ADDENDUM #4

**PROJECT: RENOVATIONS TO THE SCOTLANDVILLE BRANCH LIBRARY - PHASE II
CITY PARISH PROJECT NO. 21-ASC-CP-1449**

ADDENDUM Attachment to City Parish Addendum 4
January 27, 2025

RE: **Renovations to Scotlandville Branch Library – Phase 2**
EBR Project # 21-ASC-CP-1449

DETAIL – SUSPENDED PIPE SUPPORTS

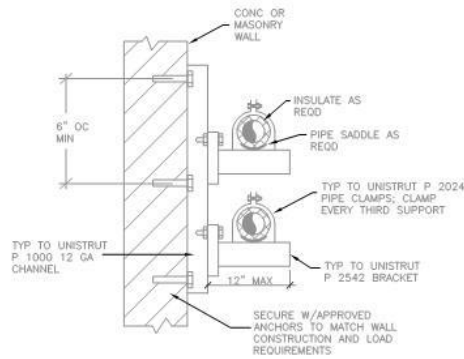
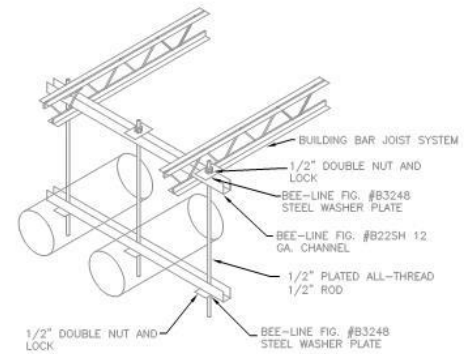
9. If all chill water mains are demoed per answering of RFI #4, can we get a detail on how to support the new pipping in the rafters?
 - a. *Refer to the following:*

- GENERAL NOTES:**
1. REFER TO ARCH DRAWINGS FOR STRUCTURE OF BUILDING.
 2. PROVIDE DOUBLE NUT AT CONNECTION AS SHOWN.

- NOTES:**
1. IF WALL IS UNSUITABLE FOR SUPPORTING PIPE RACK, CONTR. TO UTILIZE PEDISTAL SUPPORTS.
 2. SUITABLE FOR:
 - 2.1. INSULATED PIPE UP 6" AND LESS
 - 2.2. NON-INSULATED PIPE 8" AND LESS

01 DEMOLITION SITE PLAN
1" = 40'-0"

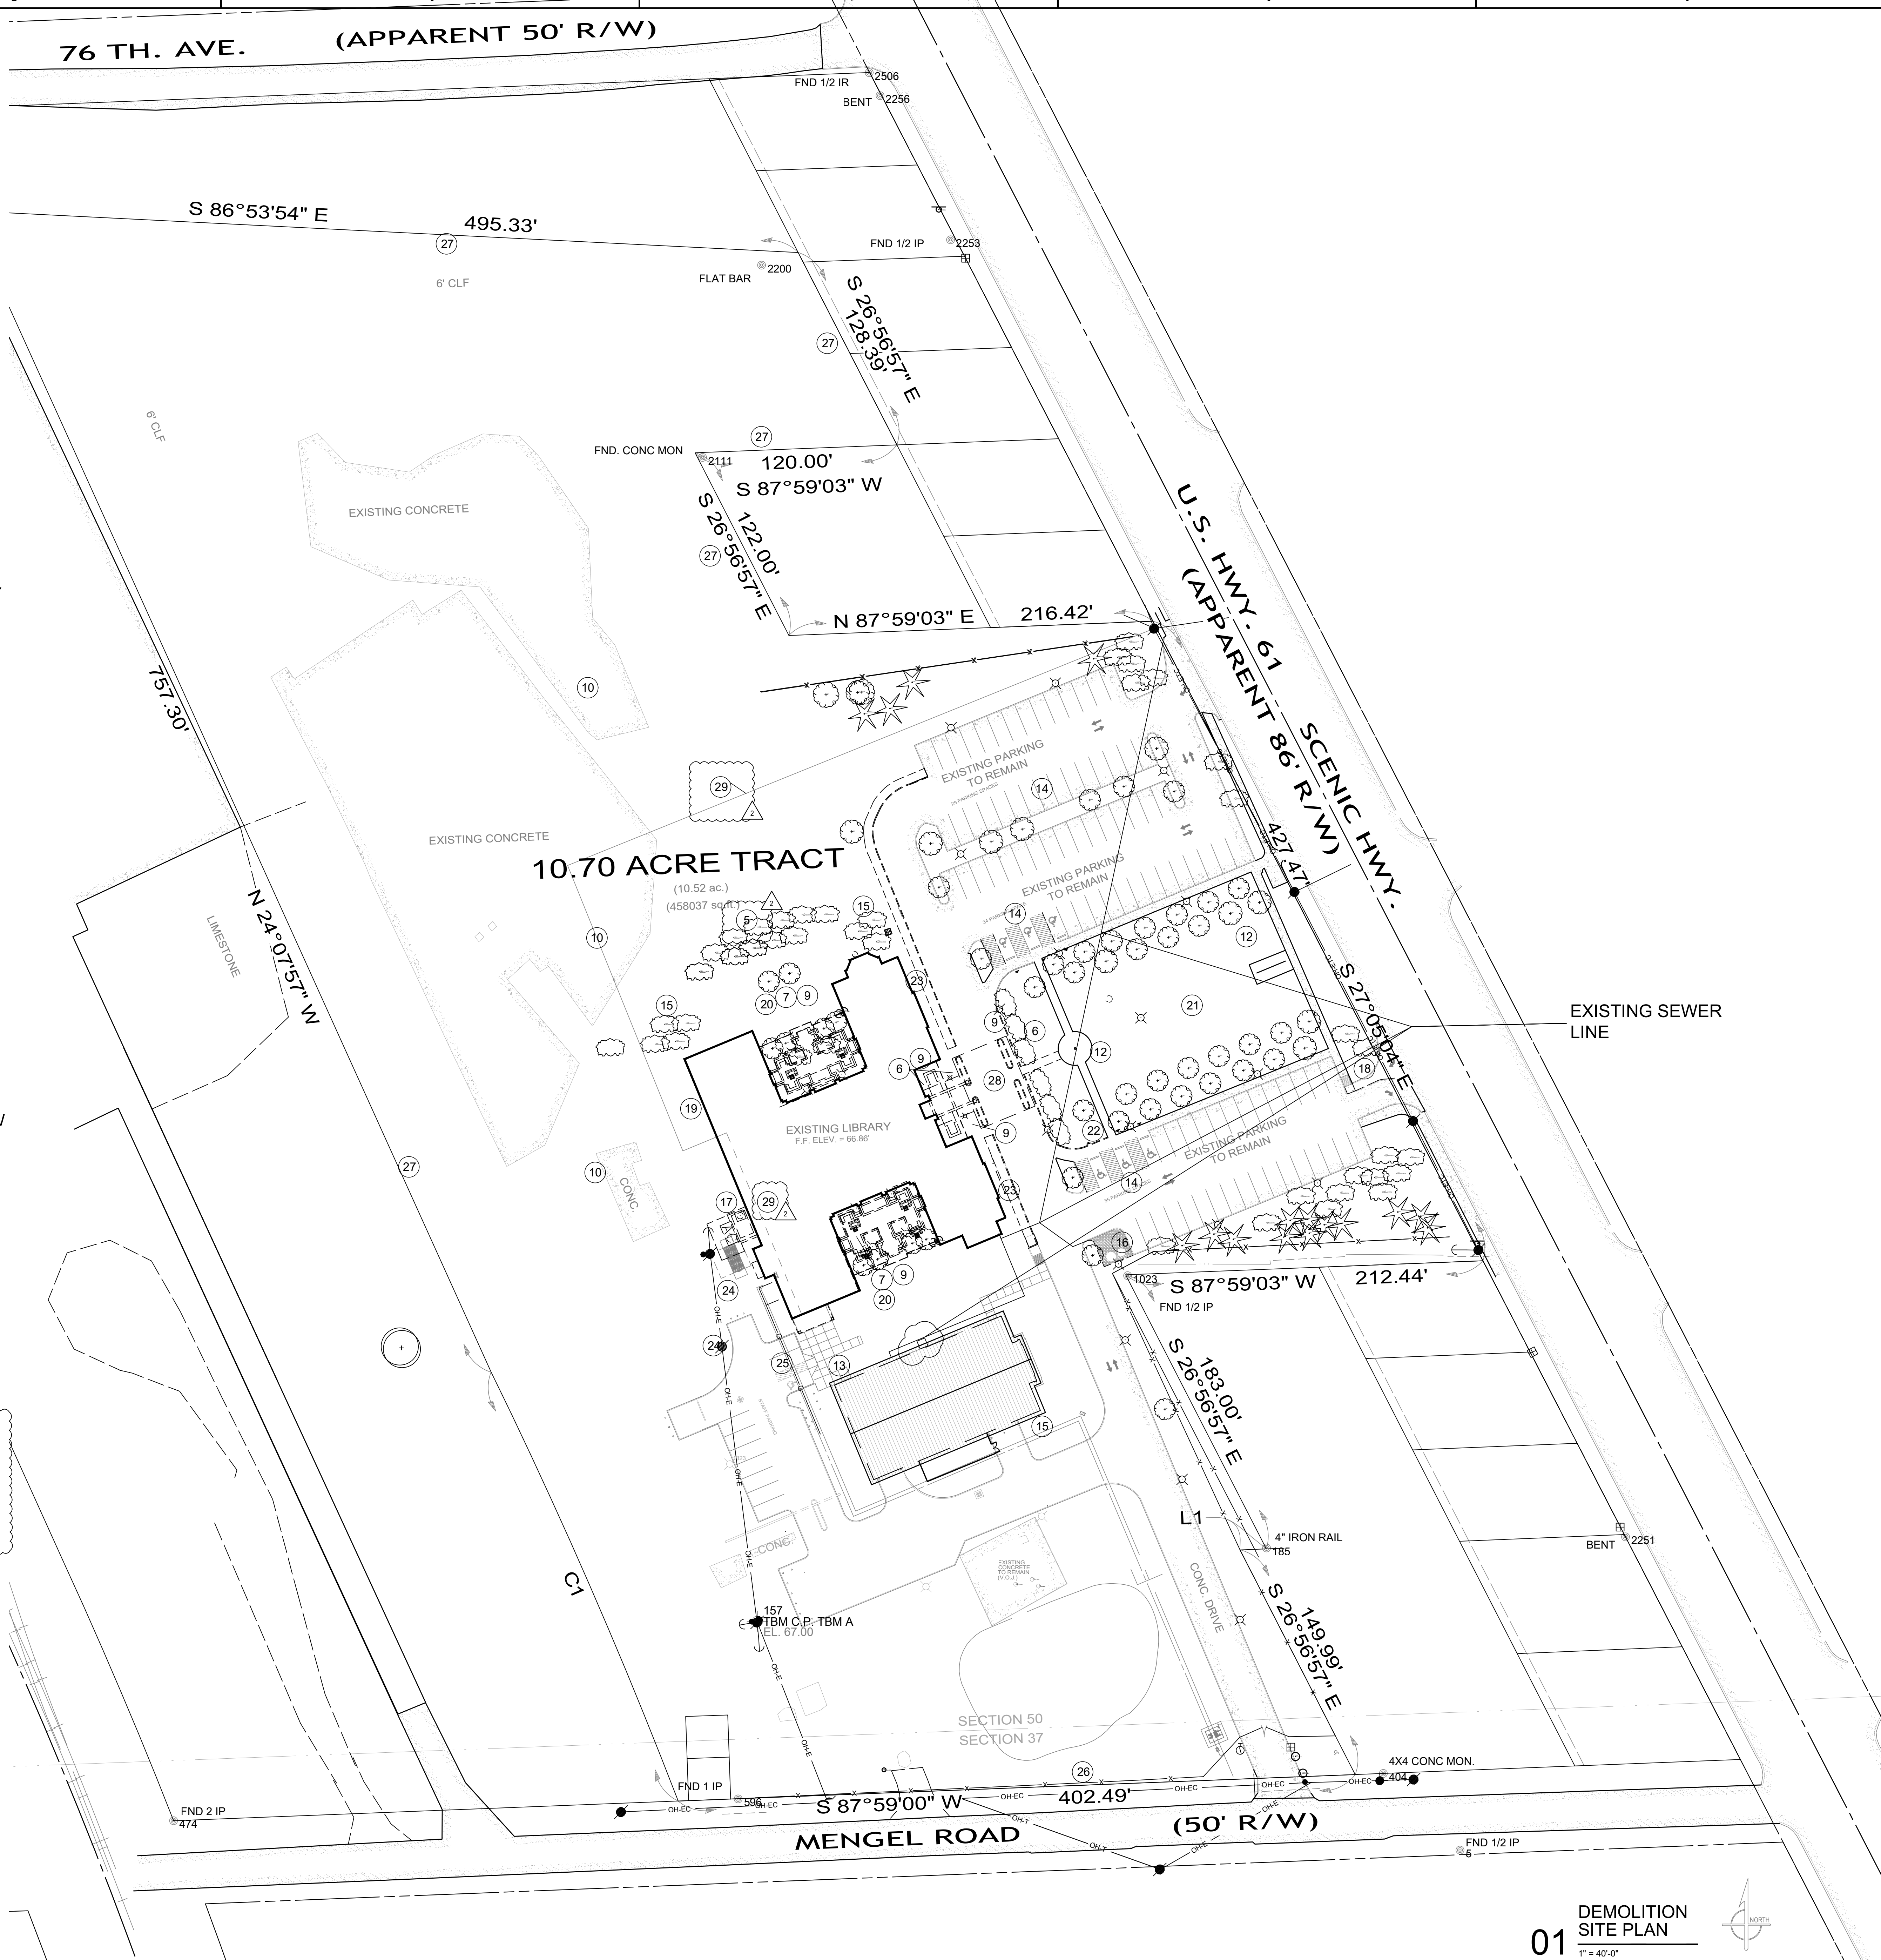
D1 – Added notes 29 & 30 and revised notes 5 & 15 at plan and revised verbiage on notes 7 & 14.
Added Cox service line & sewer line for information.

Project No.: 222706007
 Title: GEOMETRIC PLAN
 Scale: 1" = 30'
 Date: 0000.00.00
 Revision: Sheet: of
 Drawing No. C1.0

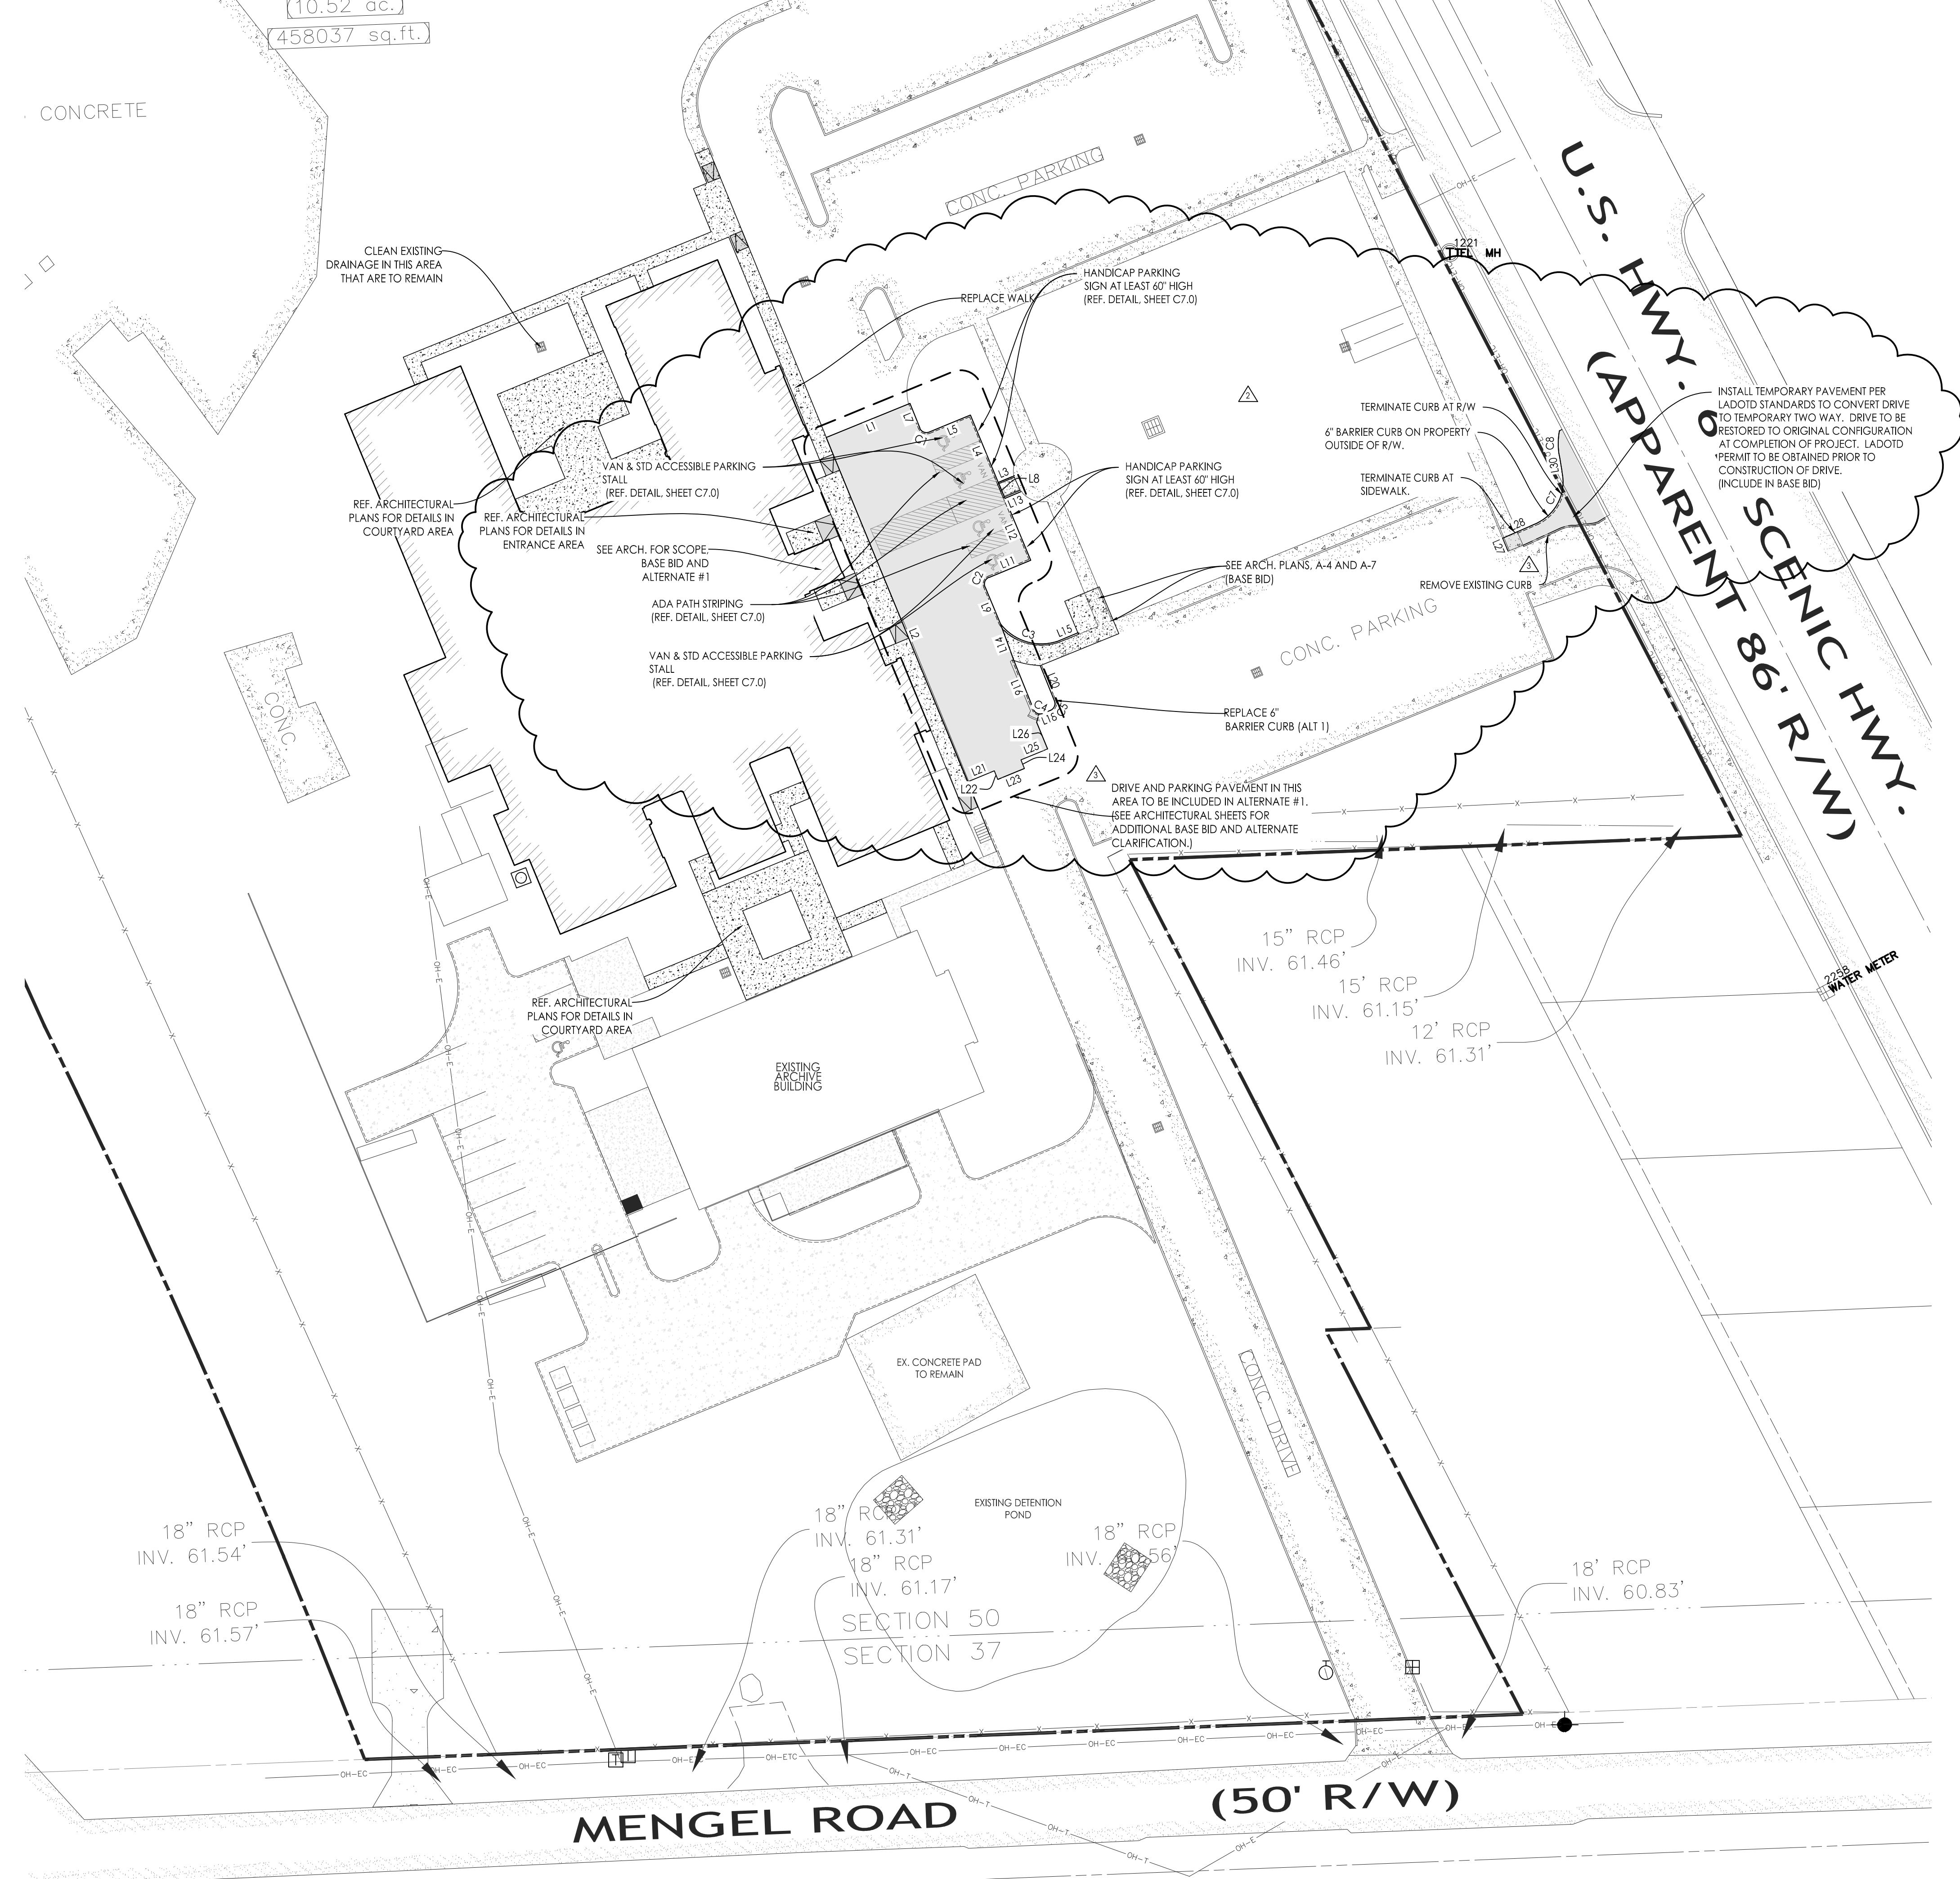
Sheet C1.0 (Geometric Plan): Updated geometry to show revised paving area. Updated to show temporary reconfiguration of driveway connection at U.S. Hwy 61 and to clarify callout of Alternate #1.
